**SUBJECT:** NuScale Power, LLC Supplemental Response to NRC Request for Additional Information No. 124 (eRAI No. 8981) on the NuScale Design Certification Application

NuScale Supplemental Response to NRC Request for Additional Information eRAI No. 8981

## **Response to Request for Additional Information Docket No. 52-048**

**NRC Question No.:** 03.04.02-1

Figure 3.8.4-27: Total Static Lateral Soil Pressure Distribution (RXB)

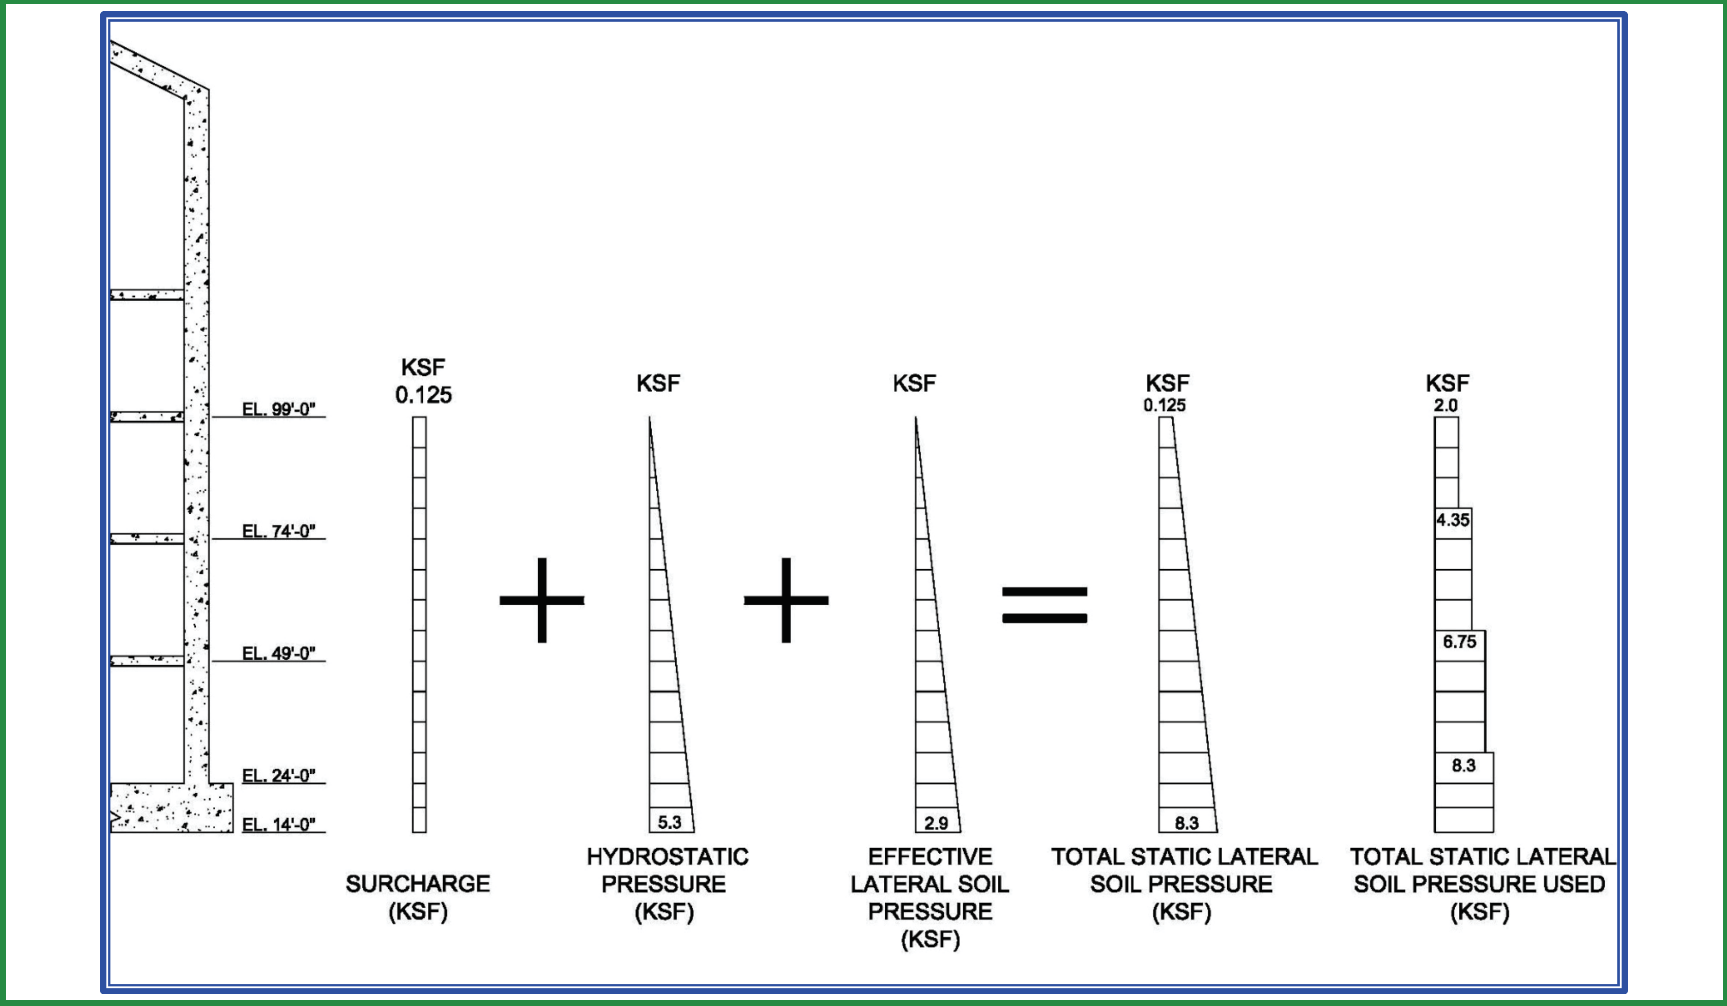
a. The staff requests the applicant to provide the analysis procedures utilized to transform the static and dynamic effects of the highest flood and groundwater levels into effective loads applied to seismic Category I structures.

b. In DCD Section 3.4.2 “Protection of Structures against Flood from External Sources,” the applicant describes that the lateral hydrostatic pressures on the structures from the design flood, in conjunction with ground water and soil pressure, are factored into the structural design as discussed in Sections 3.7.1 and 3.8.4 of the DCD. The staff did not find the lateral hydrostatic pressures due to the design flood level in the DCD Section 3.7.1. Therefore, the staff requests the applicant to describe where this information is located in the DCD or supplement the DCD to include the lateral hydrostatic pressures due to the design flood level.

The analysis procedures, provided in NuScale's original response to RAI 8981 03.04.02-1, are added to FSAR Tier 2, Section 3.8.4.3.3, based on feedback received from the NRC Staff during a public meeting on November 29, 2017.

For the static soil pressure, the lateral soil pressure is calculated assuming that the soil is completely confined and cannot move. The soil is also considered to be submerged for the total embedment depth since the water table is close to grade level. Therefore, the total horizontal pressure from the submerged soil is calculated as the sum of the hydrostatic pressure and the lateral soil pressure considering the buoyant effect. Because the water provides a buoyant effect, the effective pressure is calculated using the difference between the soil density and water density. For the Reactor Building (RXB), the embedment depth used in the mathematical model is 85'.

$$p_h = u + p_{he} + p_{hq} = 8302 \text{ psf}$$

Figure 3.8.4-27 shows a diagram of the total lateral static soil pressure distribution. Seismic soil pressure is computed from the SASSI2010 Soil-Structure Interaction analysis. The normal stresses in the backfill soil solid elements, adjacent to the embedded portion of the RXB exterior walls, represent the soil pressure. For example, for the RXB, the following table provides the summary of total soil pressures on the four walls and total overturning moments induced by the soil pressures.
